17 June 2013

**ENVIRONMENTAL ASSESSMENT FOR
PROPOSED SYDNEY HERITAGE FLEET FACILITIES
AT BANK STREET, PYRMONT
LAND TRANSPORT, TRAFFIC & PARKING ISSUES**

RESPONSE TO MATTERS RAISED BY ARUP DATED 12 APRIL 2013

ANNEXURE C:

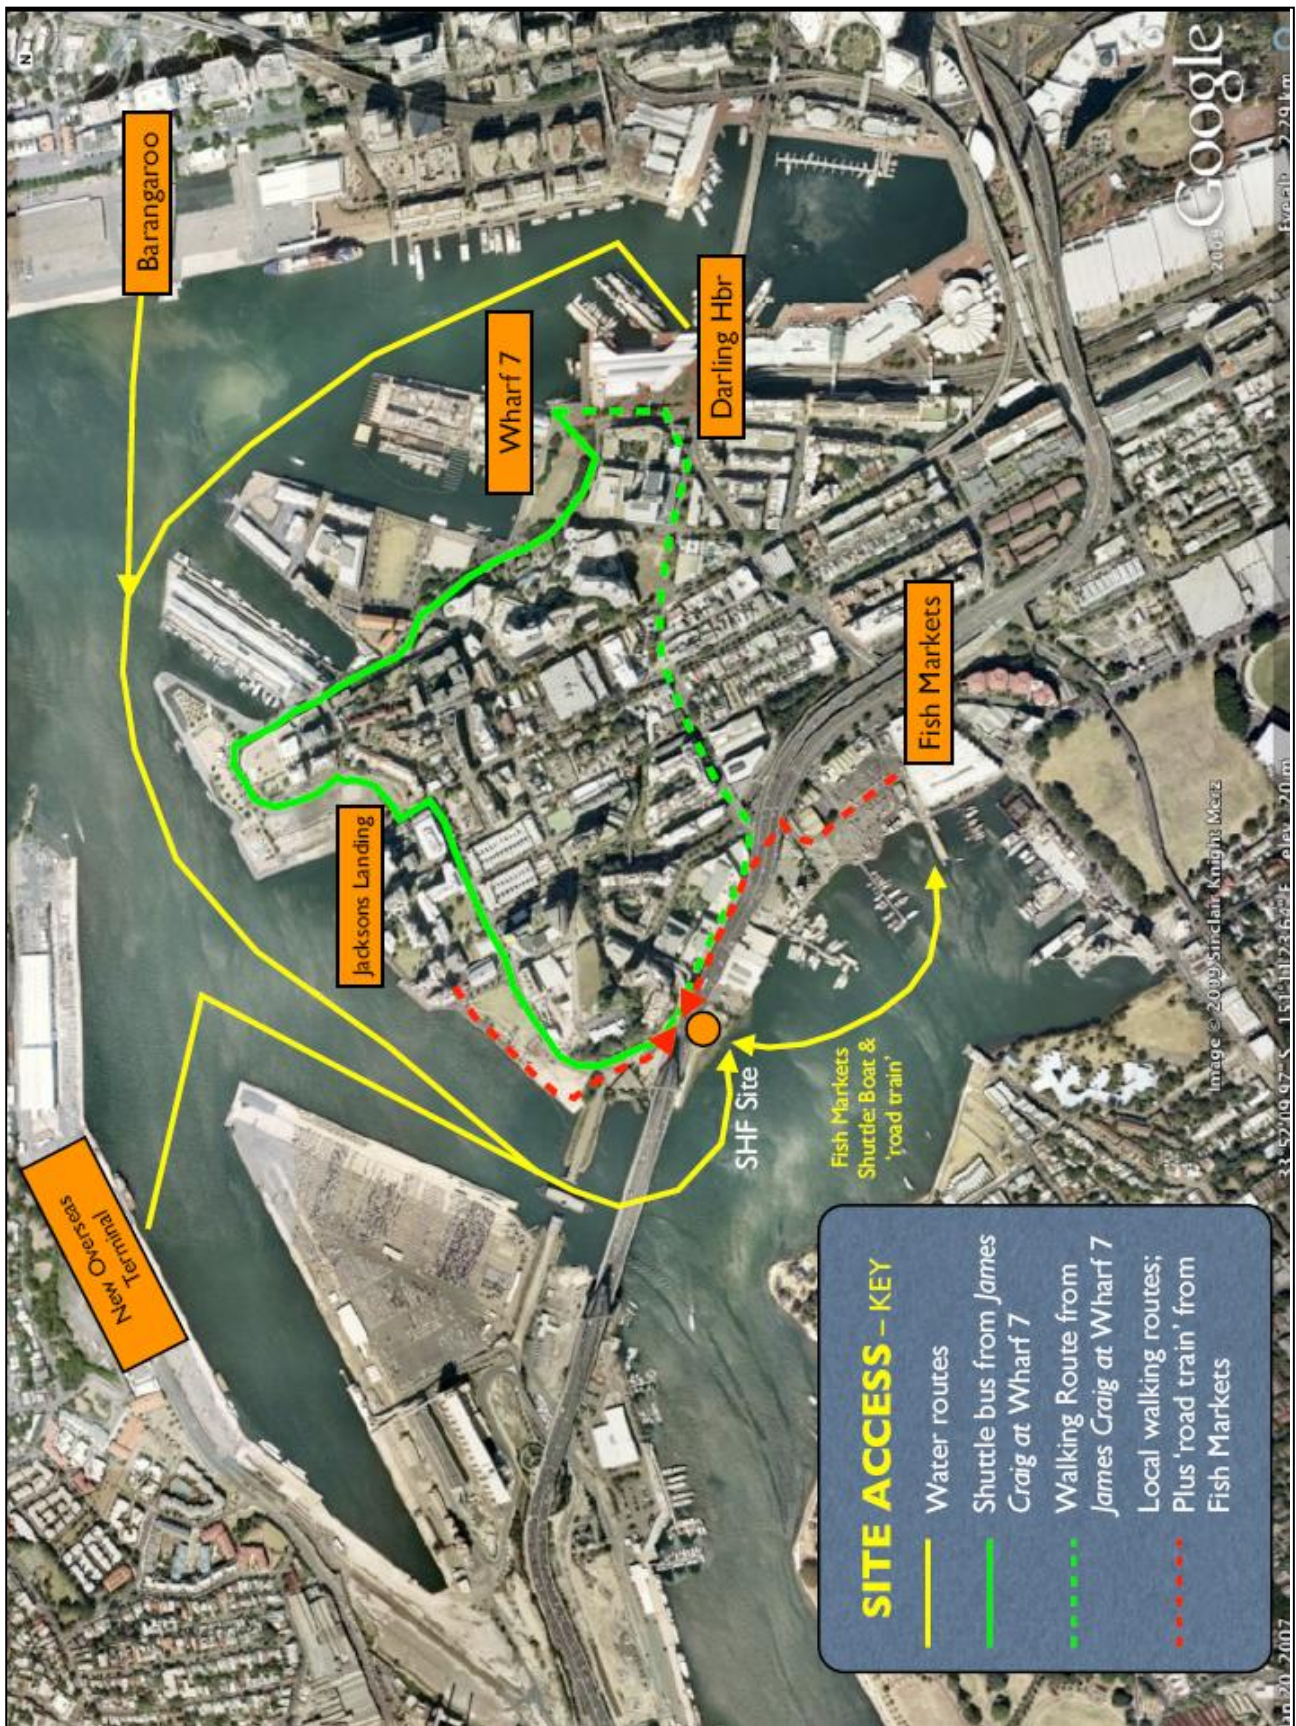
- d) Arup suggests that an assessment of the travel patterns of staff and volunteers of the existing Wharf 7 facility at Rozelle would assist in substantiating otherwise vague claims that staff and volunteers will use public transport to access the Bank Street site and will not impact on local parking.*

In relation to how staff and volunteers will be transported to and from the site **Annexures C & D** provide details of the proposed ferry services.

ANNEXURE E: 7m LONG MINI-BUS SWEEP PATH TESTS (Sheet 1 of 3)

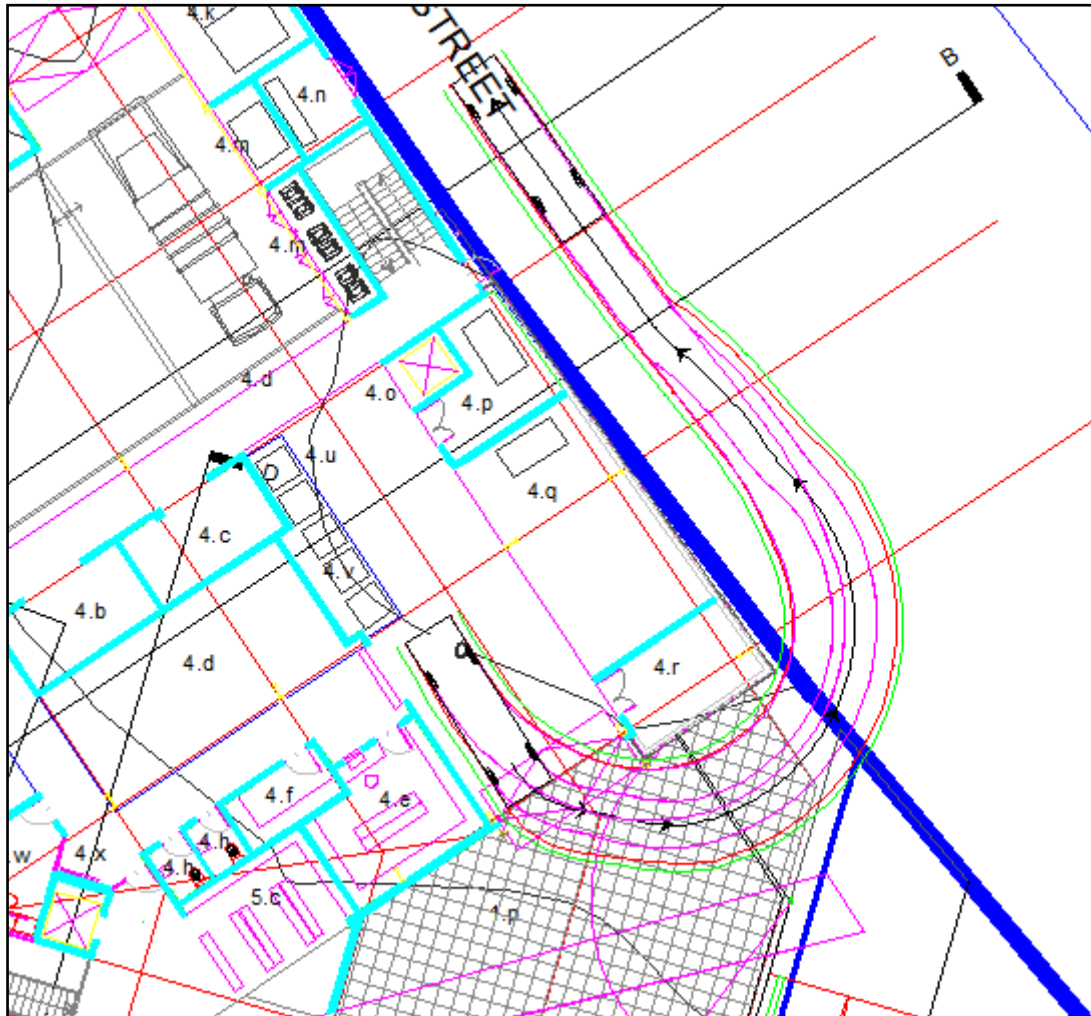
- 6. The swept path analysis for medium rigid service vehicles provided in the McLaren TMAP is not consistent with the requirements of AS2890.1 Appendix B and indicates several deficiencies. The TMAP does not demonstrate that service vehicles can adequately access the development.*

Notwithstanding the MRV conducted swept path tests the more regular vehicle that will enter the site is a 7m minibus which can deliver up to 22 patrons at any one time given that this is the seating capacity of these vehicles. As discussed previously these minibus shuttle services will operate on demand generally outside the weekday commuter peak hourly periods from Wharf 7. Minibus swept path tests are presented in **Annexure E** to this letter.

MINI-BUS RIGHT TURN INTO DRIVE WAY/LOADING AREA

1 movement, successful
